ADDENDUM NO. 2

November 2, 2021

CROWN POINT HIGH SCHOOL ADDITIONS AND RENOVATIONS **Crown Point, IN 46307**

This Addendum consists of Pages ADD 2-1 through ADD 2-2 and attached Addendum No. 2 from Gibraltar Design dated October 29, 2021 and consisting of 12 pages, Specification Section 04 01 00 - Masonry Cleaning, Specification Section 12 25 00 - Roller Shades, and 134 drawings.

GIBRALTAR DESIGN	SHEET
S	EP116

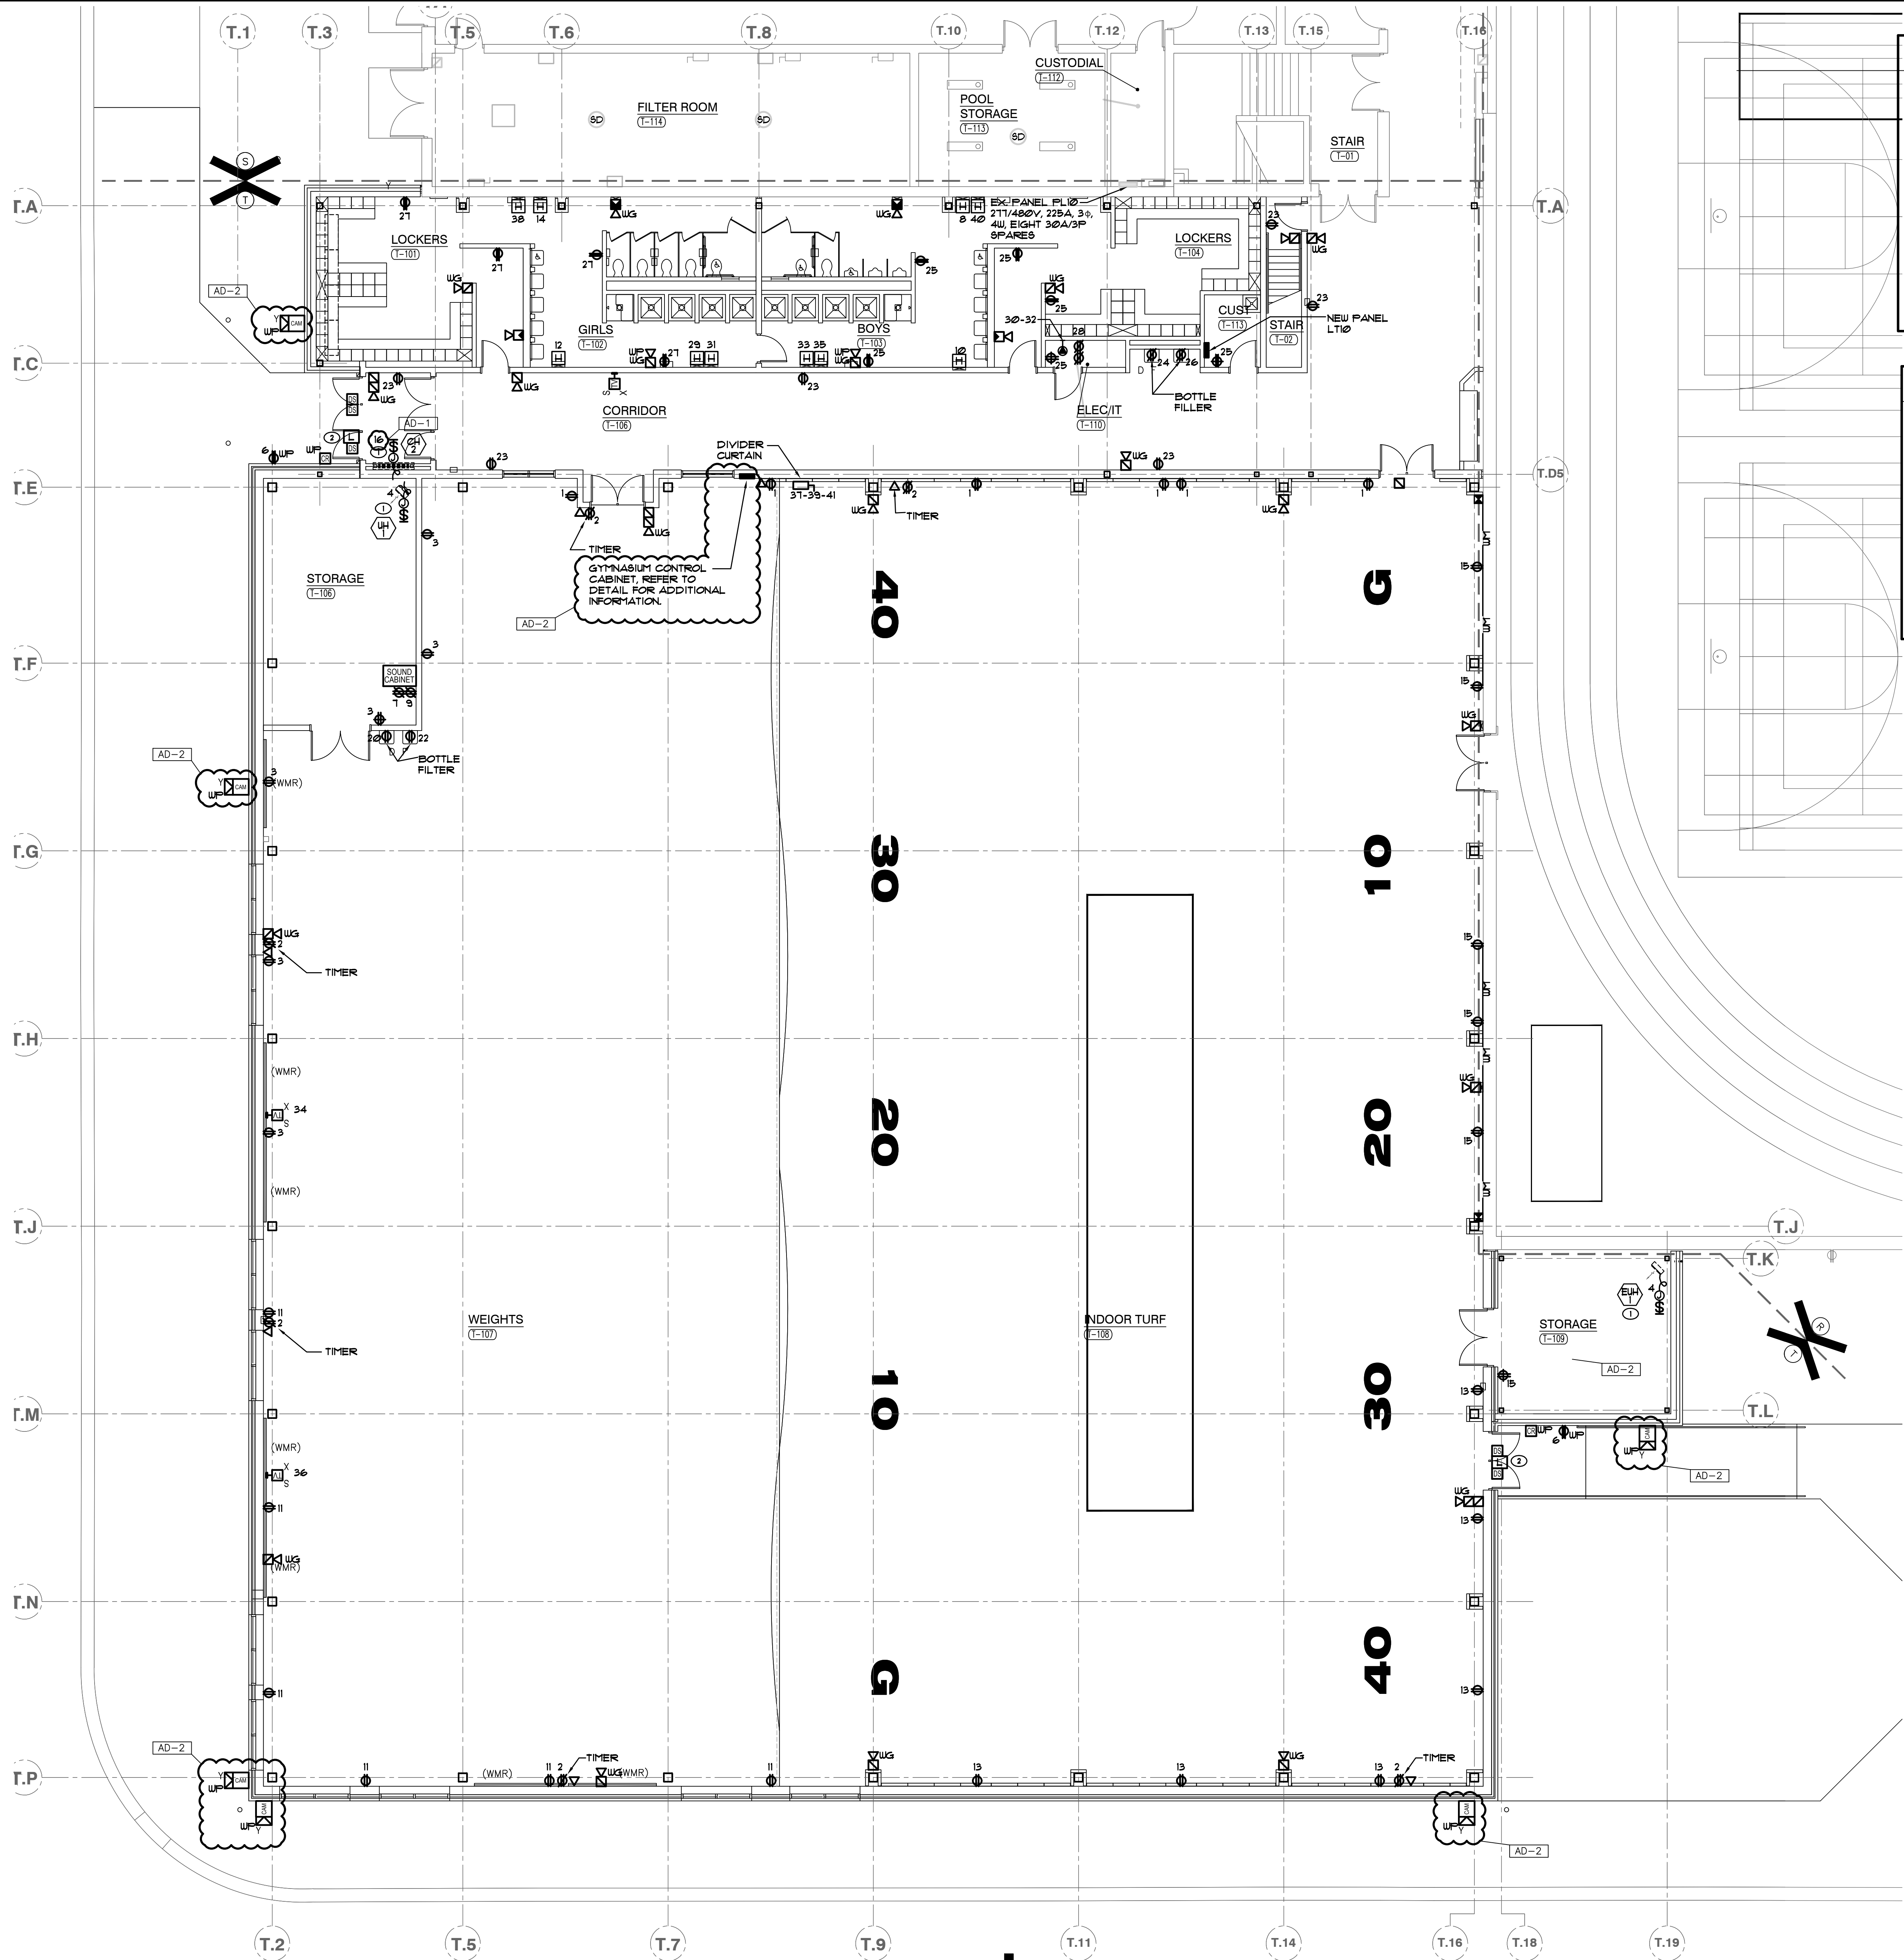
84. Sheet EP116

GIBRALTAR DESIGN SHEET
T EP117

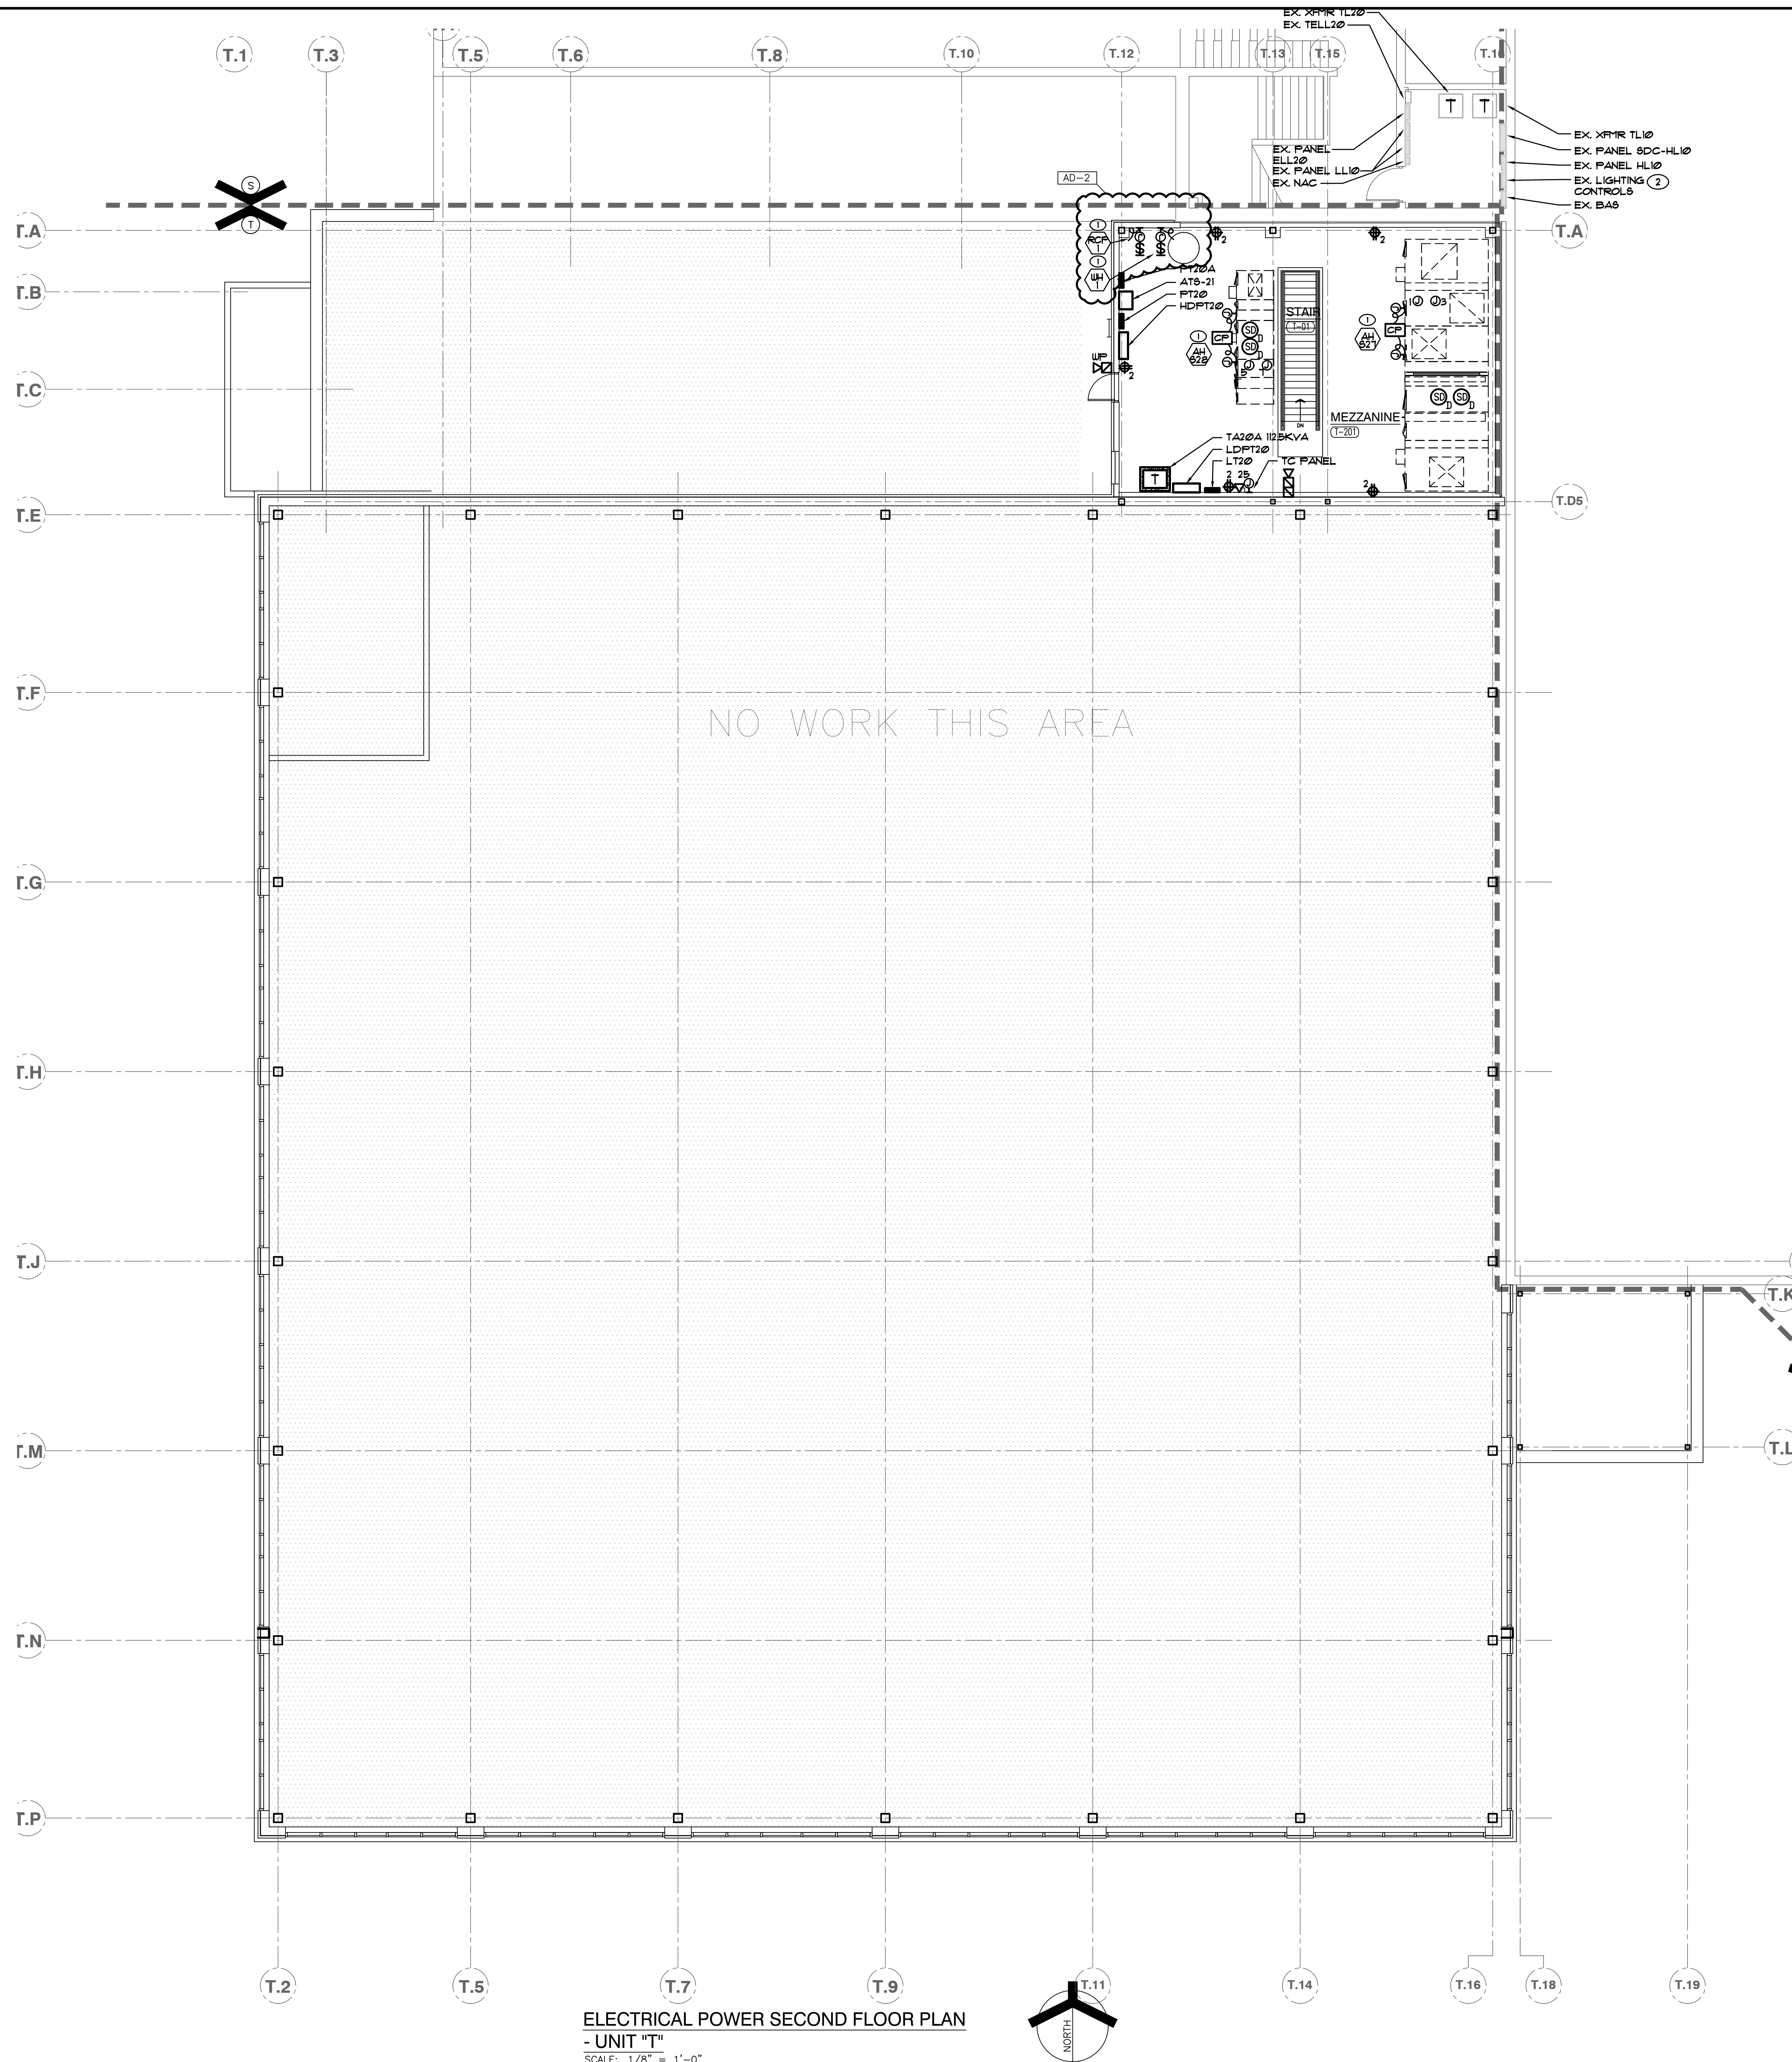
85. Sheet EP117
